Technical Service Bulletin

20 Fuel cannot be added to vehicle or fueling the vehicle is difficult

20 19 22 2044039/7 November 12, 2019. Supersedes Technical Service Bulletin Group 20 number 19-17 dated June 5, 2019 for reasons listed below.

Model(s)	Year	VIN Range	Vehicle-Specific Equipment
Q7	2017 - 2018	All	Not Applicable

Figure 1. *The broken flap inside of filler neck.*

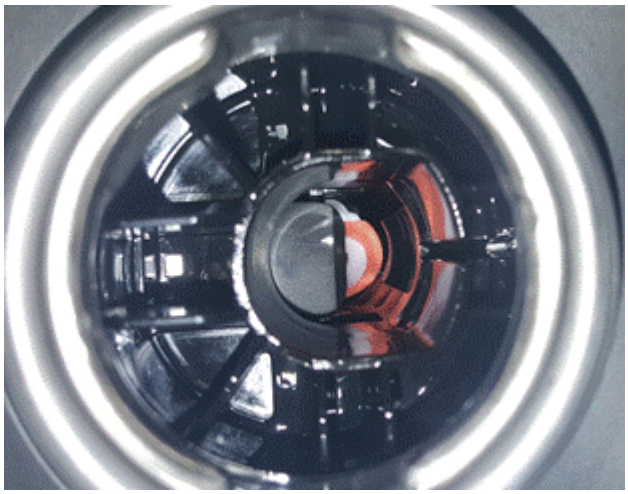
There is a broken flap inside of the filler neck (Figure 1).

Improved flap design of the filler neck.

Replace complete fuel tank according to the instructions in Elsa at Repair Manual, *Power Unit >> Fuel Supply >> Fuel tank >> Removing and installing fuel tank.*
